## Product/Process Change Notification

<b>PCN Number:</b>	100016-A	<b>Product Category:</b>	Inker Hardware	<b>Issue Date:</b>	14-Jul-14
<b>Contact:</b>	Inside Sales		E-Mail: insidesales@xandex.com		
	1360 Redwood Way, Suite A		Phone: 707-763-7799		
	Petaluma, CA 94954		Fax: 707-763-2631		
<b>Description of Change to Customer:</b>					
Solenoid coil (PN 110-0313) used in inker actuator is replaced with an alternative coil (PN 110-0318).					
<b>Reason For Change:</b>					
Existing solenoid coil has been discontinued by the manufacturer and exact replacement is not available.					
<b>Customer Impact of Change and Recommended Action:</b>					
Potential impact to unique customer inking parameters. We recommend customers verify performance with the replacement coil.					
<b>Forecasted Key Milestones:</b> Subject to change based on business conditions					<b>Date:</b>
<b>Complete Internal Qualification Testing</b>					31-Aug-14
<b>Samples Available To Order</b>					30-Sep-14

## PCN 100016-A Supplement

Physically identifying current vs. replacement coil

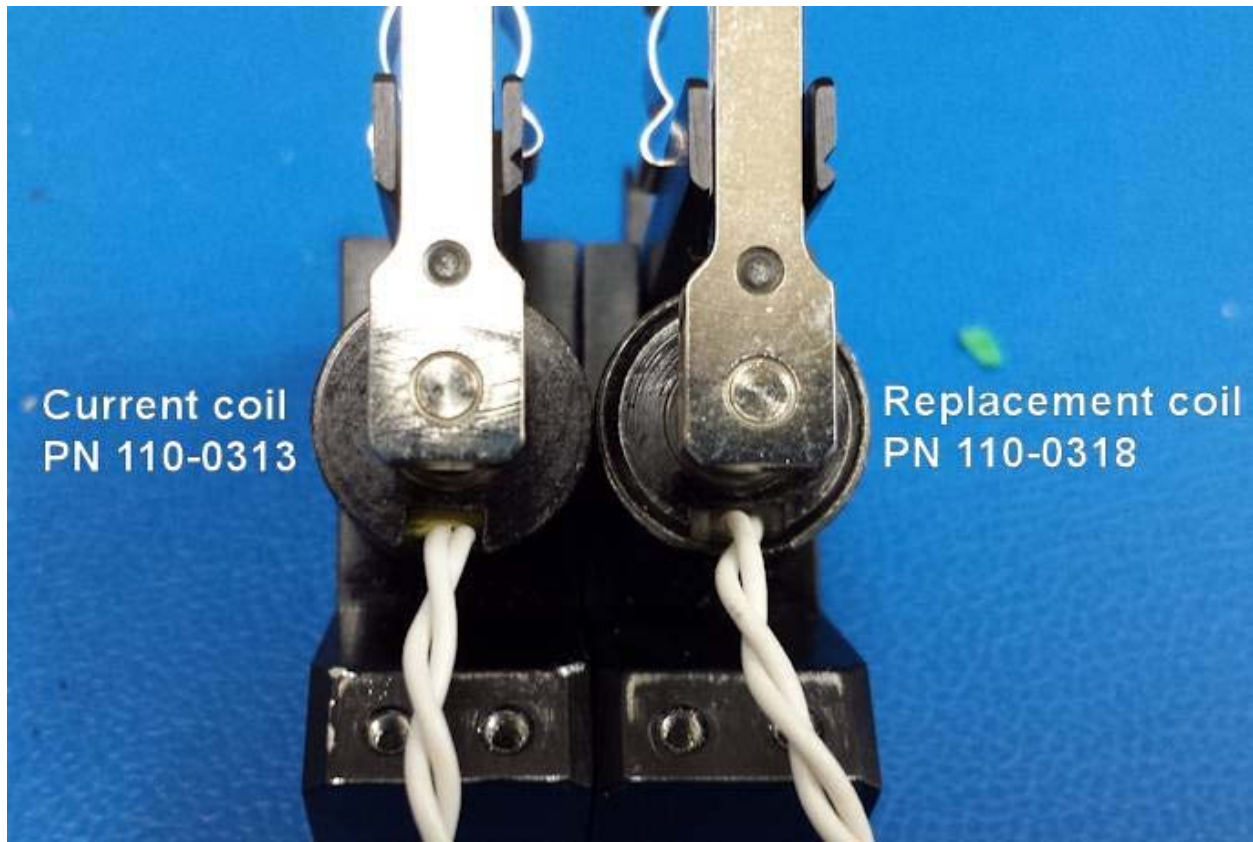
<b>First Shipment of Changed Product</b> (as early as)					13-Oct-14
<b>Last Shipment of Unchanged Product</b> (subject to material availability)					31-Dec-14
<b>Method of Identifying Changed Product:</b>					
Product revision located on package label. Also, there is a slight physical appearance change; see attached for pictorial difference.					
<b>Assessment:</b> Function change, an exact replacement is not available.

1. Greater inker coil DC resistance - 222 ohms vs. 209 ohms nominal					
2. Faster inker actuation - 7 mSec vs. 10 mSec typical					
<b>Products and Xandex Part Numbers Affected</b>					
110-0313 210-0501 210-0503 210-0504 315-0003 315-0004 315-0005					
330-0601 330-0605 330-1603					
<b>Revision History</b>					
<b>Date of Revision:</b>	<b>Revision Letter:</b>	<b>Reason:</b>			
14-Jul-14	A	Initial Publication
